CITY OF MANCHESTER
PLANNING AND COMMUNITY DEVELOPMENT

RE: ZBA2026-077, 58 Myrtle Street, B-1

Zoning Relief Required for Building Permit

ZONING REVIEW

PROSPECT SOUTH BACK

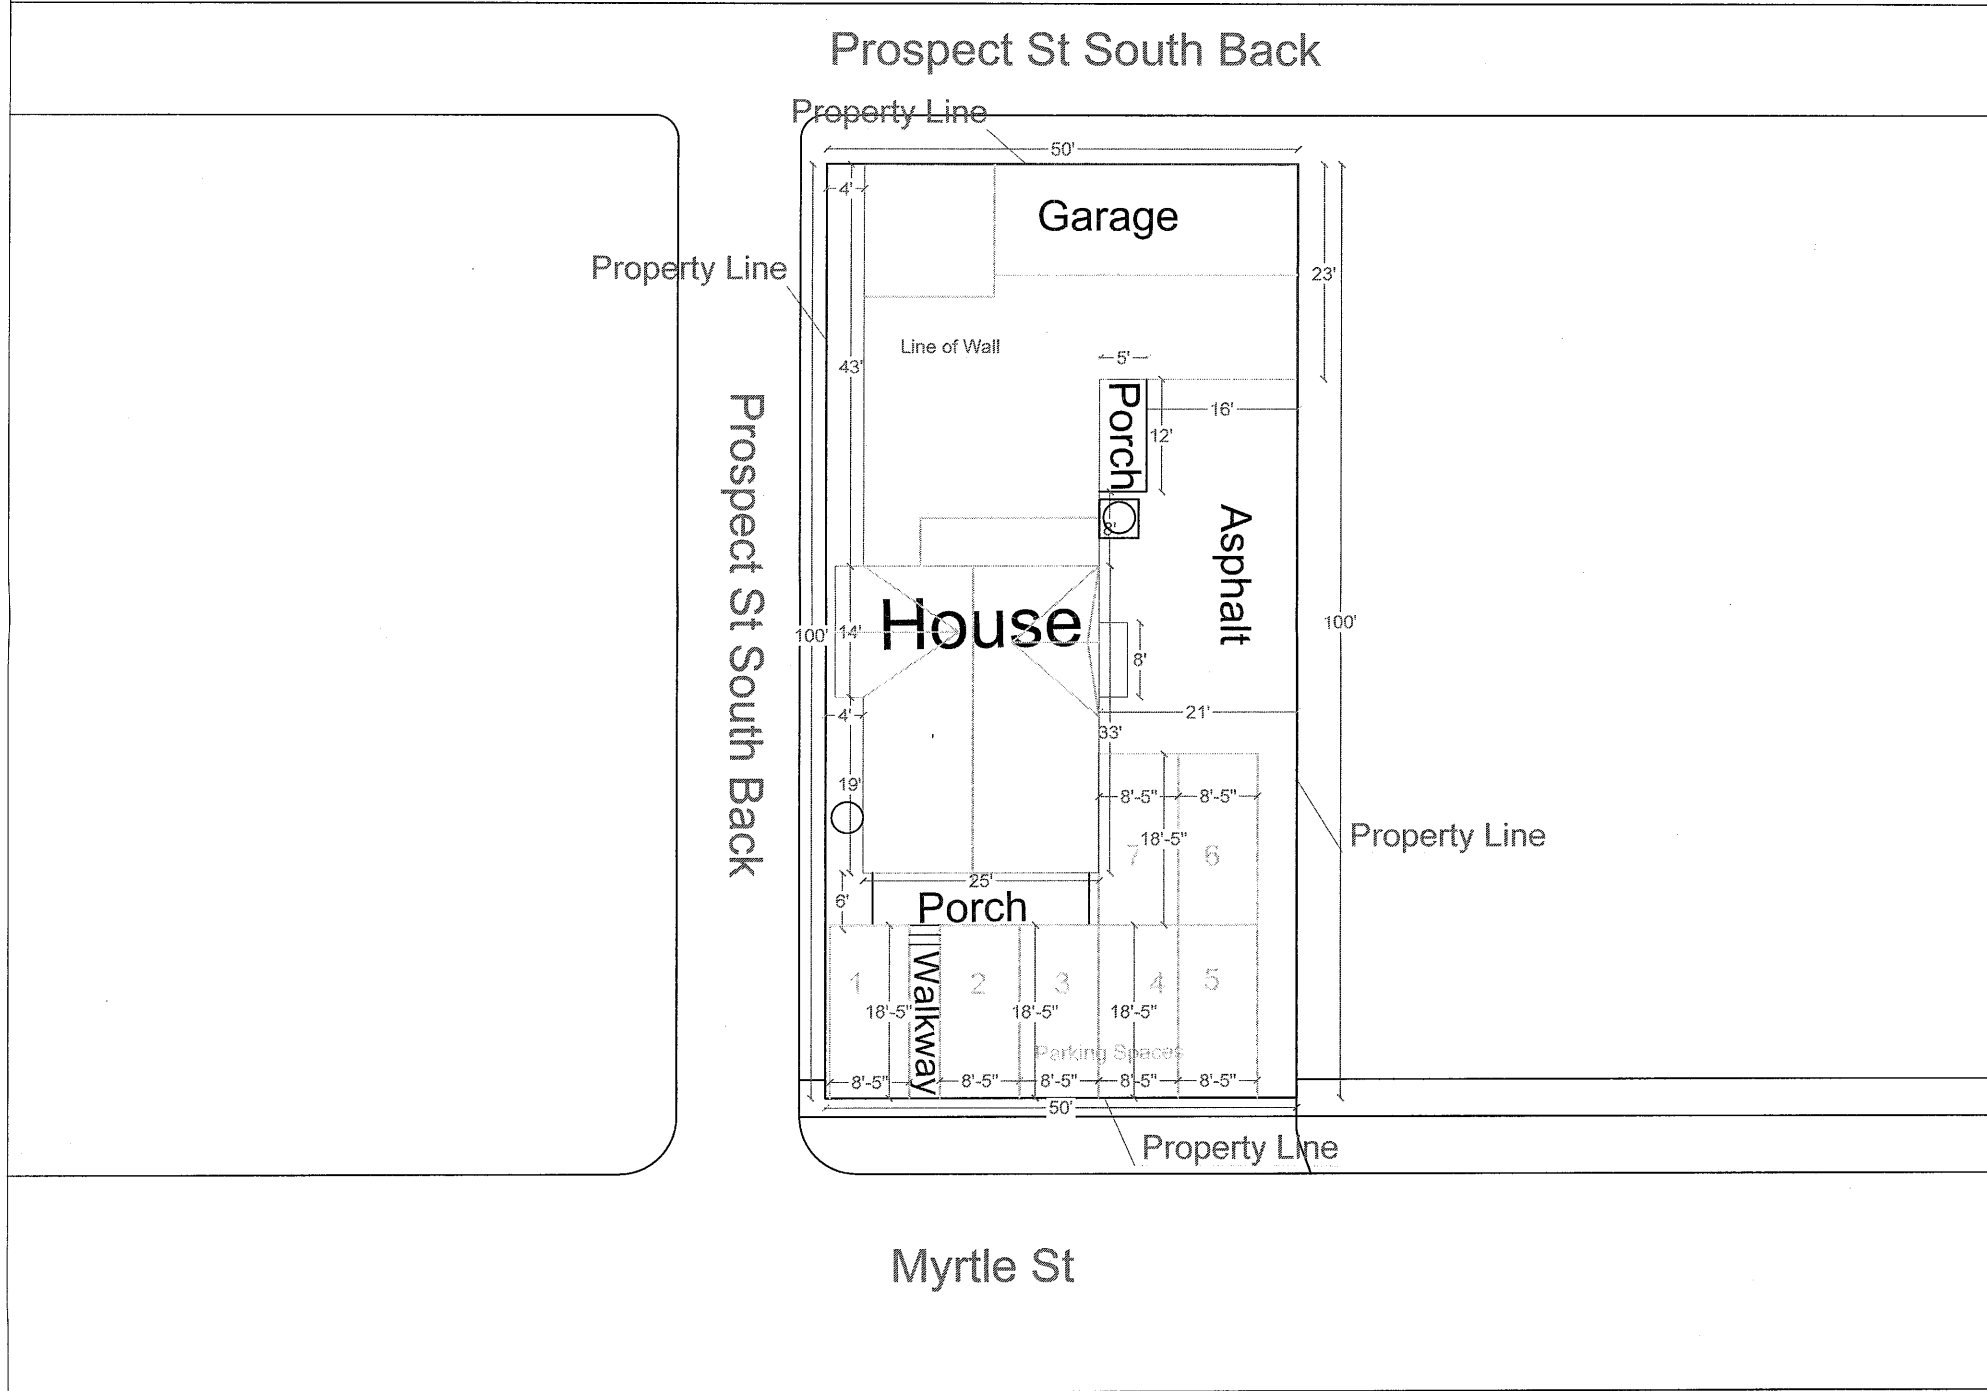
Your application for a permit dated **August 12, 2026** to maintain the expansion of a parking area to create two new parking spaces in the front yard, located directly in front of the primary façade, that require backing out onto the sidewalk to exit through the curb cut, where the driveway width is 50' at the property line where 24' is allowed, where the two spaces are within 2' of the building and one space is undersized at 15' 5" where 18.5' is required, with lot coverage of 99% where 90% is allowed, and without the required Type I Landscape Buffer around the parking area in the R-1B Zoning District, all as per documents submitted through **August 12, 2026** and with non-compliance listed in the Zoning Review dated **August 20, 2026** is hereby acknowledged.

According to Section(s) 5.3.1.F.3.I Surface Parking Location, 7.5.2.B.2 Principal Frontage Parking, 7.5.2.D Safety of Parking Design, 7.4.2.A Maximum Driveway Width, 7.5.2.A Parking Setbacks (2 counts), 7.3-A.B Parking Layout, 5.3.1.F.3.H Maximum Lot Coverage, and 8.1.1.B Type I Landscape Buffer of the Zoning Ordinance of the City of Manchester, New Hampshire, passed to be ordained on March 1, 2026, this is prohibited. Consequently, I have no authority to grant this permit. Permit is hereby DENIED.

Article 7 Parking Requirements		Section	Permitted/ Required	Proposed/ Existing	Remarks
☒	Surface Parking Location	5.3.1.F.3.I	Side or Rear Yard	Front & Side	N/C
☐	Garage Location	5.3.1.F.3.J	Side or Rear Yard	Rear	OK
☐	Parking, Number of Spaces	Table 7.2-A	5	9	OK
☐	Parking Surfaces	7.3.2	Required	Proposed	OK
☒	Maximum Driveway Width	7.4.2.A	24 ft.	50 ft.	N/C
☒	Parking, Setbacks, From Lot Lines	7.5.2.A	See Ord.	See Plan	N/C
☒	Parking, Setbacks, From Building	7.5.2.A	See Ord.	See Plan	N/C
☒	Parking, Principal Frontage	7.5.2.B.2	See Ord.	See Plan	N/C
☒	Parking, Tandem	7.5.2.C.2	See Ord.	See Plan	N/C
☒	Parking, Safety of Design	7.5.2.D	See Ord.	See Plan	N/C
☒	Parking Dimensions	Table 7.3-A.B	18.5 ft.	*15.5 ft.	N/C - Survey indicates *17.5 ft
☐	Parking Lot Perimeter Landscape	8.1.5.A		N/A	
☐	Parking Lot Interior Landscape, Tree Distribution	8.1.5.B		N/A	
☐	Landscape Islands	Distribution	8.1.5.C.1		N/A
☐		Island Dimensions	8.1.5.C.2

Article 8 Site and Landscaping Standards		Section	Permitted/ Required	Proposed/ Existing	Remarks
☒	Landscaping, Applicability	8.1.1.B	Required	Proposed	N/C - Removing in front yard.
☐	Landscaped Buffer Yards, Buffer Yard Type Standards	Table 8.1.2-A	Type 1	See Plan	See Above
☐	Landscaped Buffer Yards, District Boundaries	Table 8.1.2-B		N/A	
☐	Landscaped Buffer Yards, Use Abutting R or MX District Boundaries	Table 8.1.2-C		N/A	
☐	Fences and Walls	8.2			
☐	Fence Height	Table 8.2.4-A	4 ft.	Existing 4'	OK
☐			8 ft.	Existing 4'	OK
☐			8 ft.	None	OK
☐	Height of Fences on Walls	8.2.4.A	4 ft.	None	OK
☐	Setback of Retaining Walls > 4 ft.	8.2.4.B	10 ft.	None	OK
☐	Screening of Dumpster & Utilities	Table 8.3-A			
☐	Visibility at Intersections	8.4	30 ft.		
☐	Site Lighting Standards	8.5			
☐	Open Spaces	8.6
